# HISTORIC AND DESIGN REVIEW COMMISSION

**HDRC CASE NO:** 2022-346  
**ADDRESS:** 506 STIEREN  
**LEGAL DESCRIPTION:** NCB 2966 (STIEREN STREET REPLAT), BLOCK 1 LOT 18  
**ZONING:** RM-4, H  
**CITY COUNCIL DIST.:** 1  
**DISTRICT:** King William Historic District  
**APPLICANT:** Caroline Gado  
**OWNER:** APOLLO MAYORAL LLC  
**TYPE OF WORK:** New construction of four, multi-story structures  
**APPLICATION RECEIVED:** June 13, 2022  
**60-DAY REVIEW:** Not applicable due to City Council Emergency Orders  
**CASE MANAGER:** Rachel Rettaliata

## REQUEST:

The applicant is requesting conceptual approval to construct four residential structures on the lot addressed 506 Stieren. The proposal includes three, 3-story structures and one, 2-story structure.

3 SITE PLAN  
3/32" = 1'-0"

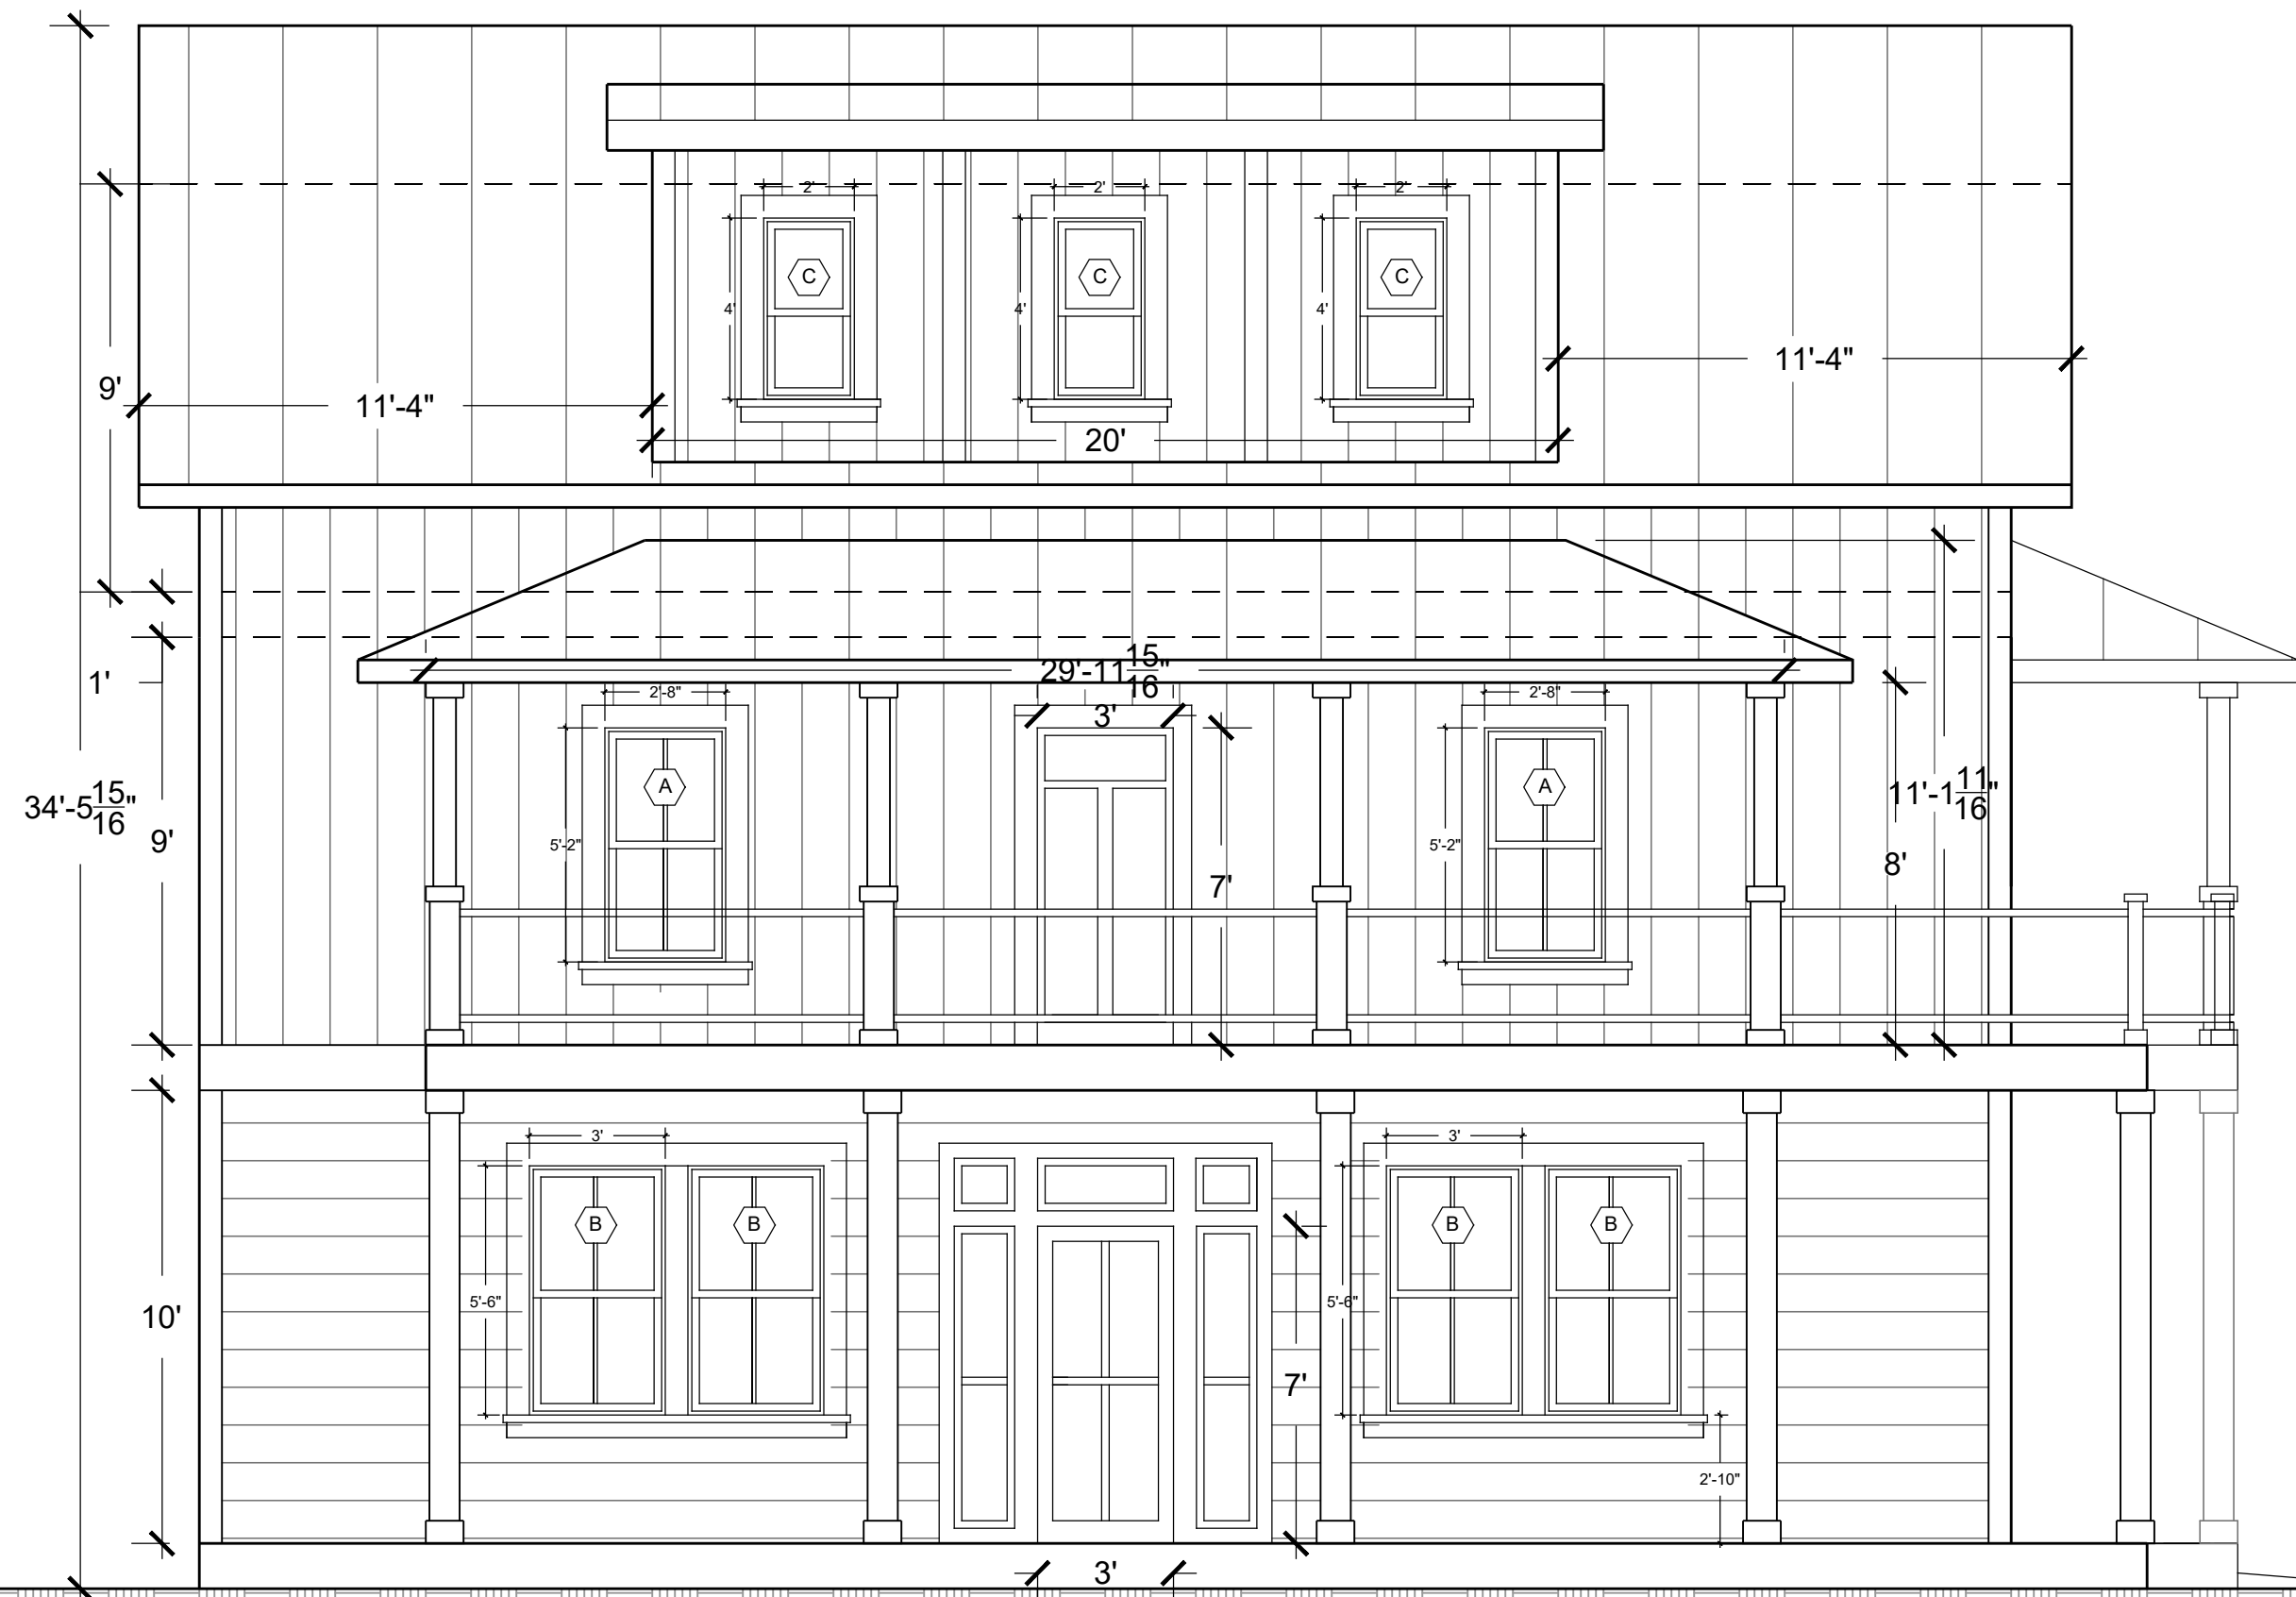
- f. FOOTPRINT – Per the submitted conceptual site plan, the front unit along Stieren will have the largest footprint of the four structures, with the three interior structures featuring a similar overall rectangular footprint. The documents include a lot coverage calculation for the building footprint, which states that the overall lot measures 9,234 square feet, the building footprints measure 3,588 square feet, for a building-to-lot ratio of 38.86%. According to the Historic Design Guidelines, new construction should respond to the existing development pattern of the district and buildings and impervious coverage should not exceed 50% of the lot. Historic lots in the district do not traditionally four detached structures. The predominant development pattern for residential lots is a larger primary structure and a smaller detached accessory structure in footprint. While the building footprints total less than 50% coverage of the lot, a calculation for total impervious cover is not provided. Staff does not find the proposed footprint consistent with the Guidelines. Staff finds that the applicant

should explore a revised site configuration and building number that is more consistent with historic development patterns and lot coverage found in the neighborhood.

- l. **LOT COVERAGE** – According to the Historic Design Guidelines, new construction should be consistent with adjacent historic buildings in terms of the building to lot ratio. The building footprint for new construction should be limited to no more than 50 percent of the total lot area. The documents include a lot coverage calculation for the building footprint, which states that the overall lot measures 9,234 square feet, the building footprints measure 3,588 square feet, for a building-to-lot ratio of 38.86%. According to the Historic Design Guidelines, new construction should respond to the existing development pattern of the district and buildings and impervious coverage should not exceed 50% of the lot. The applicant has not provided a formal lot coverage percentage for buildings and impervious cover. Staff does not find the proposal consistent with the level of information provided at this time.

- i. That the applicant explores a revised site configuration and building number that is more consistent with historic development patterns and lot coverage found in the neighborhood as noted in finding d, e, and k.
